Rio Fashion Wear Ltd

Industrial Plot No.3, Milk Vita Road, Section 7, Mirpur, Dhaka
(23.81596N, 90.3625E)

2 November 2013

Site Observations

Column aggregate type

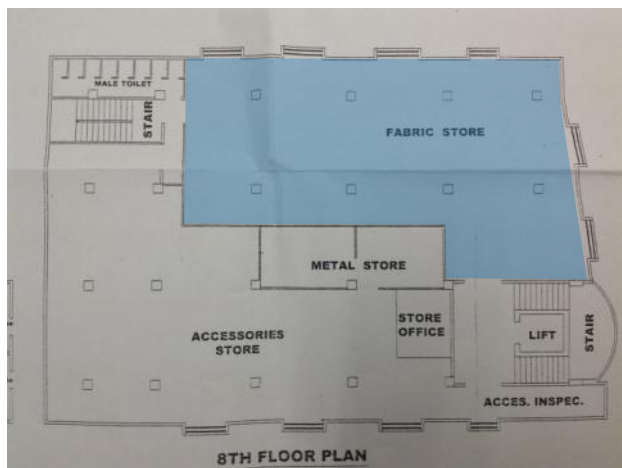
Design drawings indicate stone aggregate concrete was to be used. 8th floor column opened for Schmidt Hammer test clearly showing concrete contains brick aggregate

3 columns opened up at basement level were found to be stone aggregate. It is unknown at what level the columns change to brick aggregate. This needs to be confirmed as the column working stress is very high for brick aggregate concrete.

Heavily loaded bonded warehouse

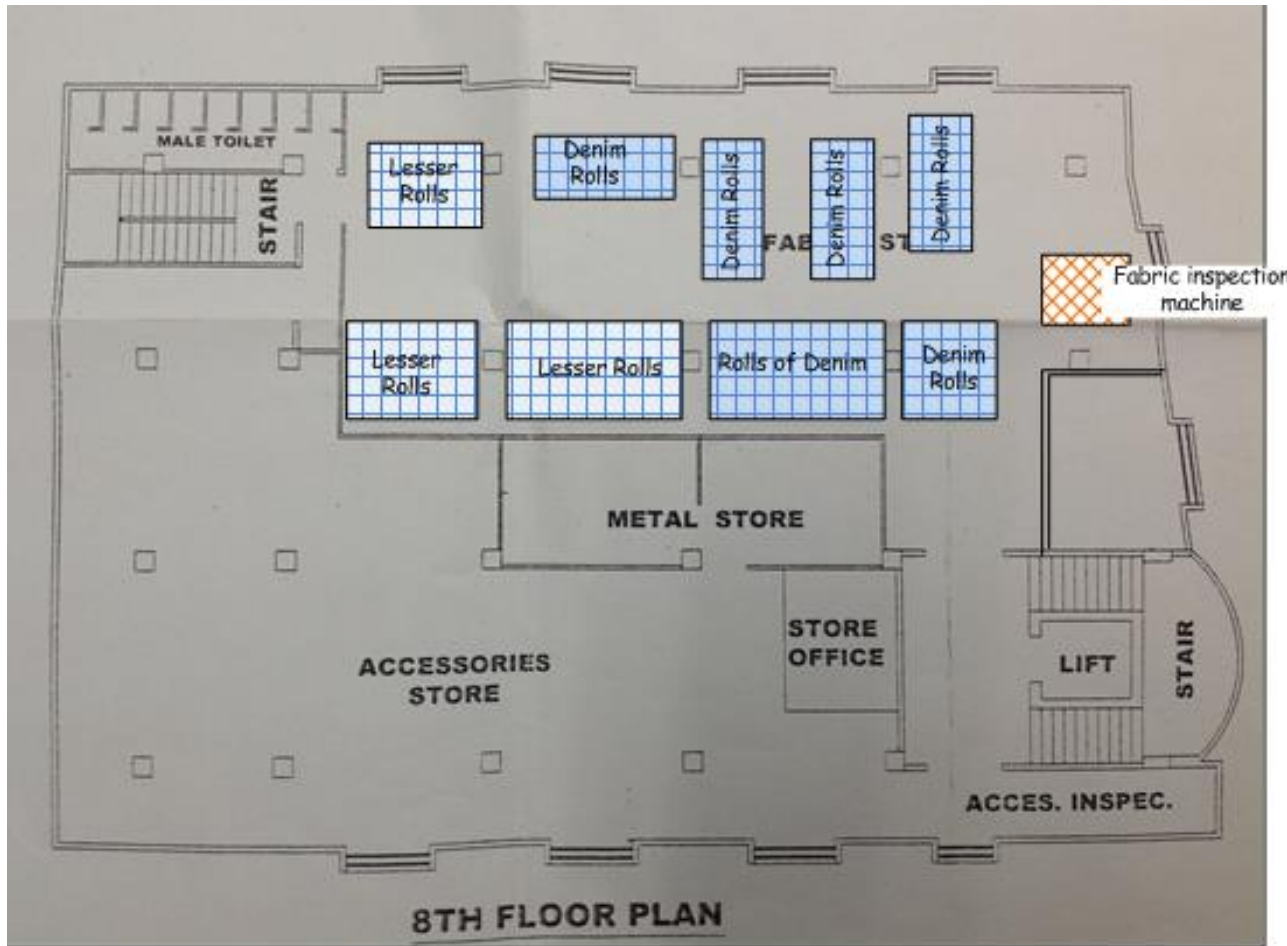
Rolls of denim stacked 2m high over areas of 1.5m x 3m

Loading in this area needs to be reduced See below

Reduce height of stacked fabric rolls to a maximum height of 1.5m

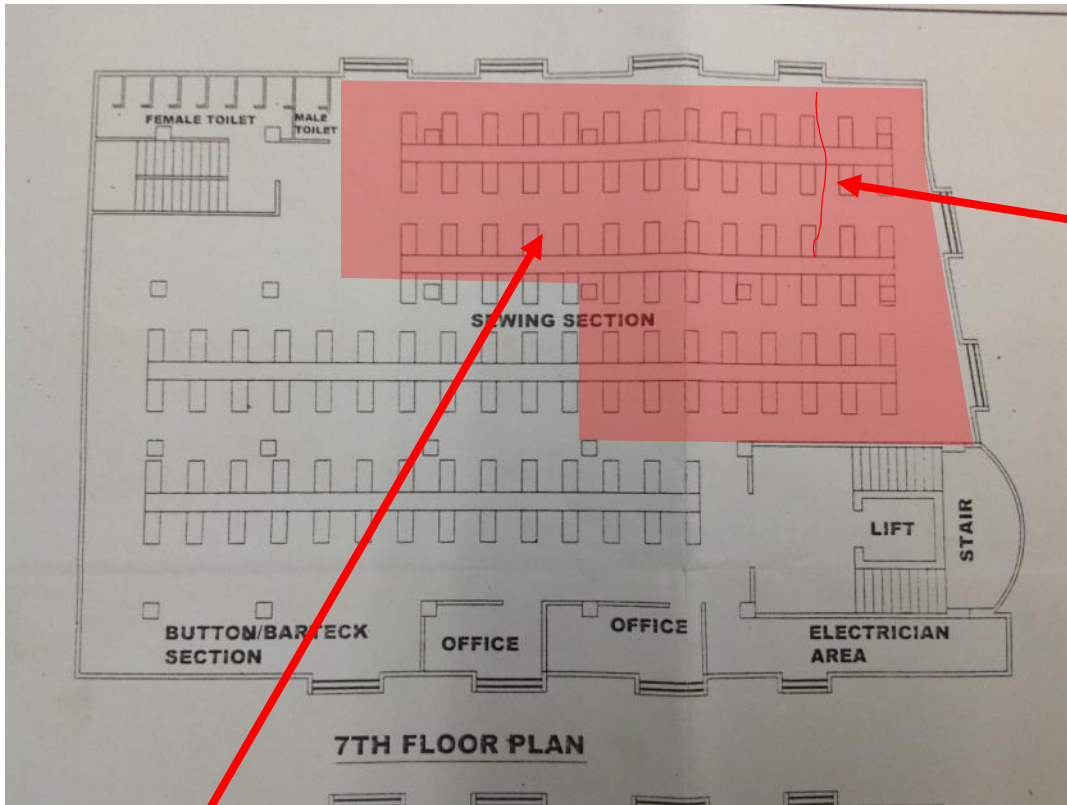
Multiple hairline cracks in underside of 8th floor slab

Crack opened up with hammer revealed voids in concrete

Remove all items from the column bay directly over cracked area. No imposed load permitted until slab is assessed and repaired

Steps in rear facade

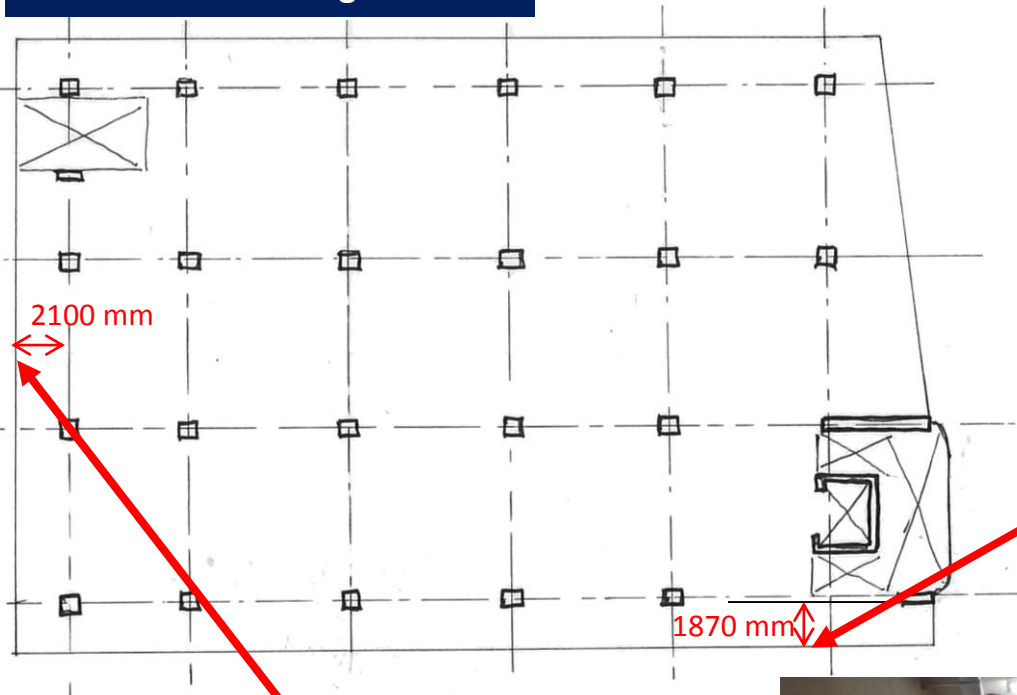
Steps in façade at 2nd and
ground not shown on drawings

Item 1 and Actions

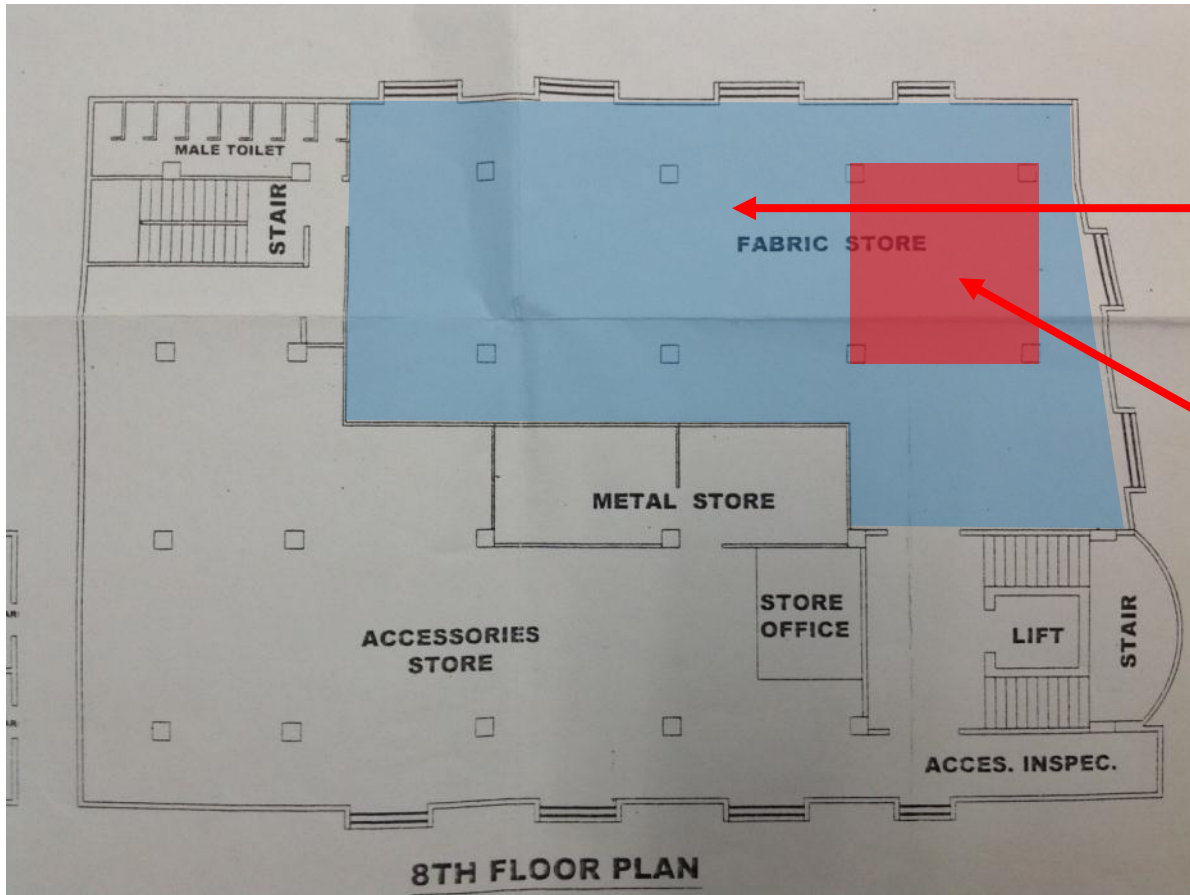
10	Heavy loading in fabric store on 8th floor has resulted in overloading of the slab and cracking to the soffit of the 7th floor	Qualified Engineer to assess slab, confirming reinforcement diameter, condition and cover depth). Check for voids in slab under storage area using Non-Destructive Testing apparatus.	6-weeks
11	Heavy loading in fabric store on 8th floor has resulted in overloading of the slab and cracking to the soffit of the 7th floor	If voiding is not extensive in situ repair may be feasible with imposed loads on 8th floor limited to a quantified design capacity. If voiding is extensive slab will need to be propped and strengthening options developed.	6-weeks
12	Heavy loading in fabric store on 8th floor has resulted in overloading of the slab and cracking to the soffit of the 7th floor	Manage loads on 8th Floor. Do not exceed capacity of slab determined from above assessment (Priority 2).	6-months
